COUNTY OF LOUDOUN

MEMORANDUM

DATE: April 20, 2010

**SUBJECT: ZMAP-2010-0001 and SPEX-2010-0003
HS-7 Dulles South and Elementary School**

ATTACHMENT A – EXAMPLE POCKET TREE SAVE AREA

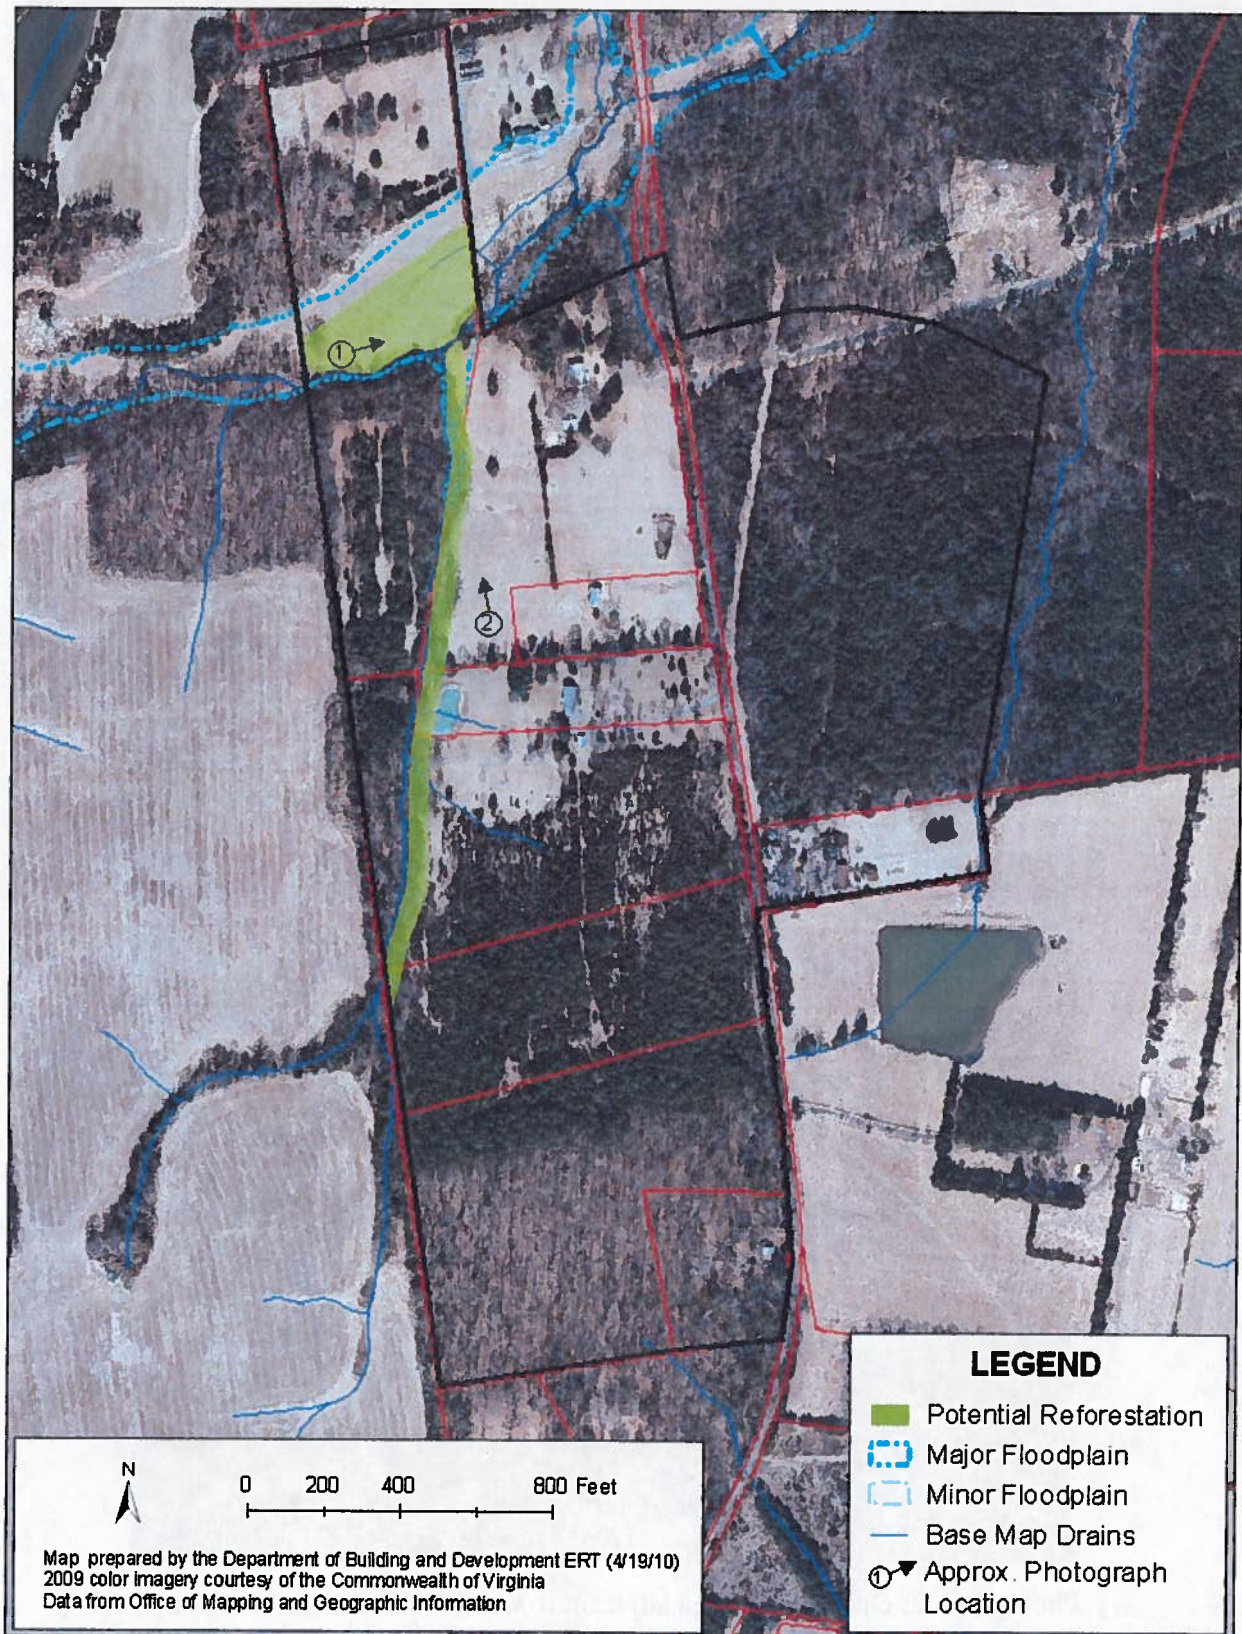
- 1) Staff reviewed the Forest Management Plan & Cover Type Map, prepared by Zimar & Associates, Inc., dated February 15, 2005. Cover Type 1, consisting of upland hardwoods, located in the southern portion of the property, is the most desirable tree cover for preservation on the subject property. The hardwood tree stand corresponds to the proposed elementary school site. Staff recommends exploring all opportunities to preserve portions of the tree stand within the development layout, including perimeter buffers and a pocket tree save area separating the elementary school site from the high school baseball and softball fields (adjacent to the phase line). Attachment A provides an example pocket tree save area. [Revised General Plan (RGP) Forests, Trees, and Vegetation Policy 1]
